CITY OF ALBUQUERQUE

RE: **Sonic @ 8th and Bridge
Drainage and Grading Plan
Engineer's Stamp Date 6/5/17
Hydrology File: L14D025A**

Based upon the information provided in the submittal received on 6/5/17, the Drainage and Grading Plan cannot be approved for building permit until the following comments are addressed:

DRAINAGE AND GRADING PLAN

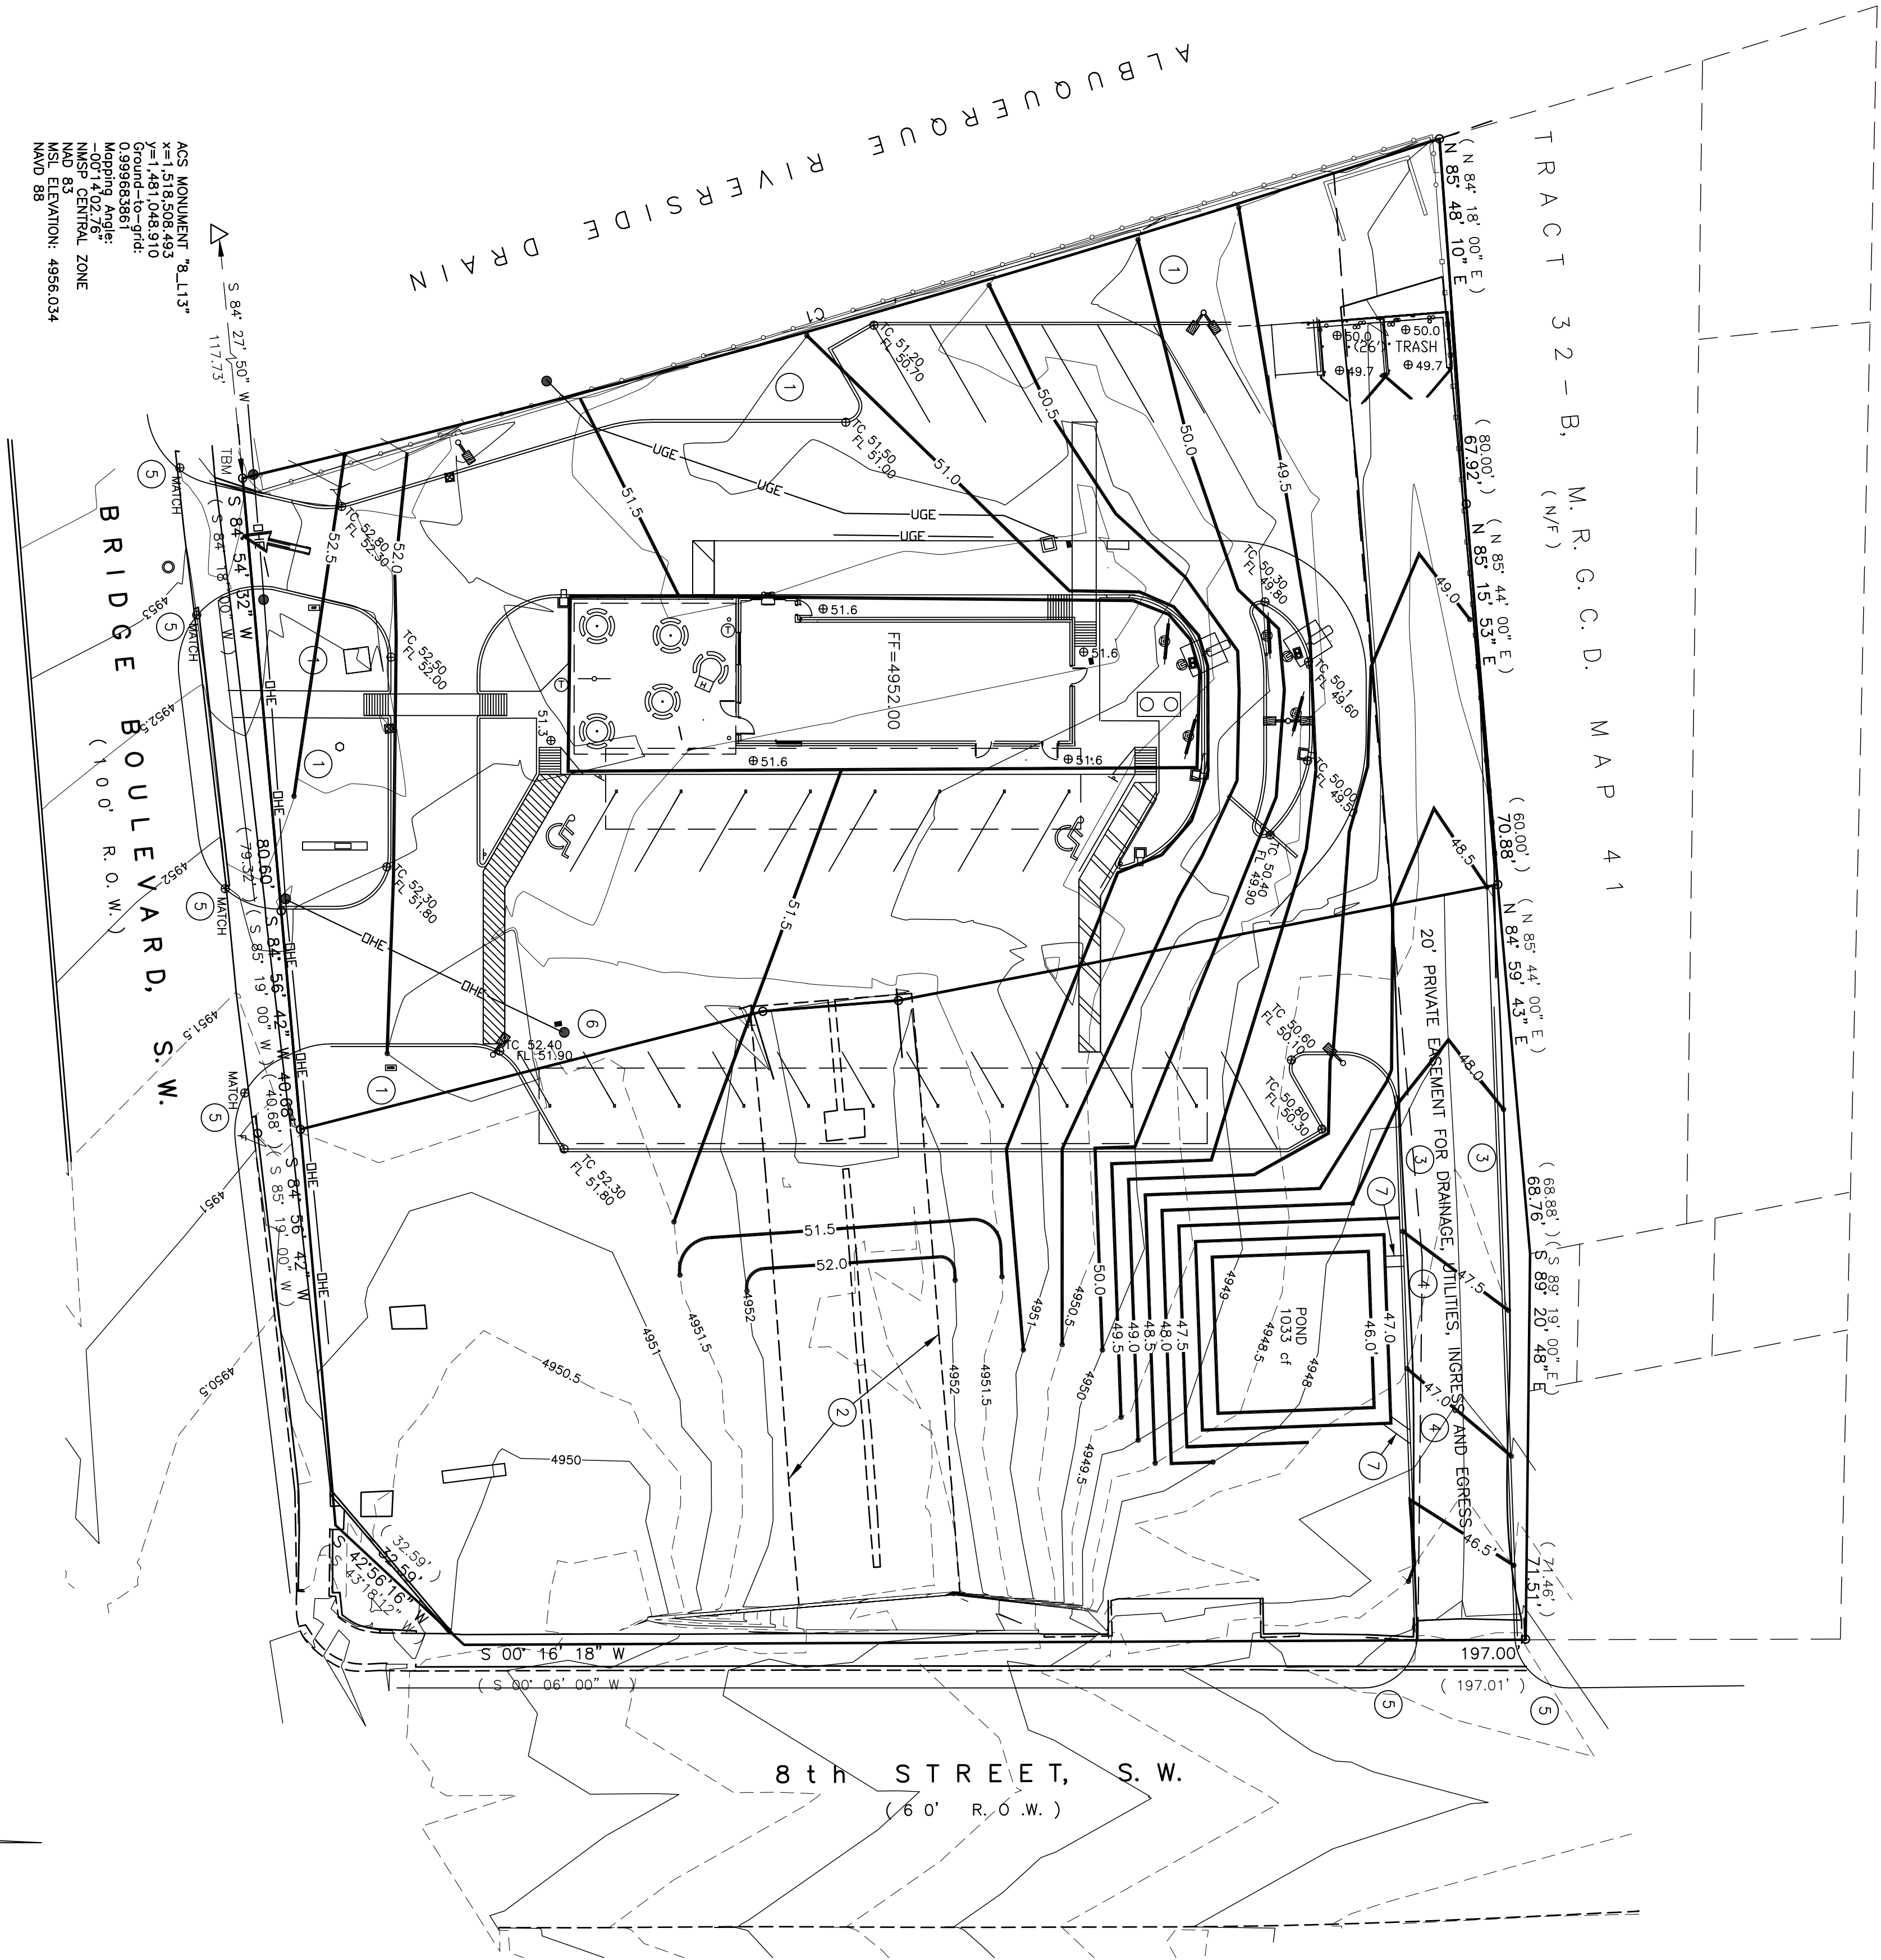
1. The site must demonstrate adequate downstream capacity per § 14-5-2-12 (10)(G) of the Albuquerque Code of Ordinances.
2. The drainage plan and narrative description must provide an offsite drainage basin map showing all areas that drain through and around the site to a reasonable analysis point that demonstrates downstream capacity.

3. Provide more detail on the proposed grades. Specifically, the proposed contours appear to ignore the curb heights and several of the spot elevations.

4. The alley section needs to transition to a cross-slope sooner in order to route flows into the pond.
5. Provide additional details for the Rip-Rap rundowns: size, thickness, dimensions, flowlines, flow capacity, invert elevations, etc.

6. Provide waterblocks, at least 0.67' high, at the entrances off Bridge to prevent flows from entering your site from Bridge.
7. Provide an existing conditions sheet (or Demo sheet) showing facilities to remain and those to be removed.

8. The dumpster area will need to be contained drained through a grease trap, and into the sanitary sewer.
 9. Include all items in the legend.
 10. This site will require an ESC Plan to be submitted to the Stormwater Quality Engineer (Curtis Cherne, PE ccherne@cabq.gov) prior to Building Permit approval.
 11. Standard SO-19 notes need to be included on the plan.
 12. A cross lot drainage easement is required between Lots A and B.
 13. A private facility drainage covenant is required for the pond
- If you have any questions, please contact me at 924-3695 or dpeterson@cabq.gov.
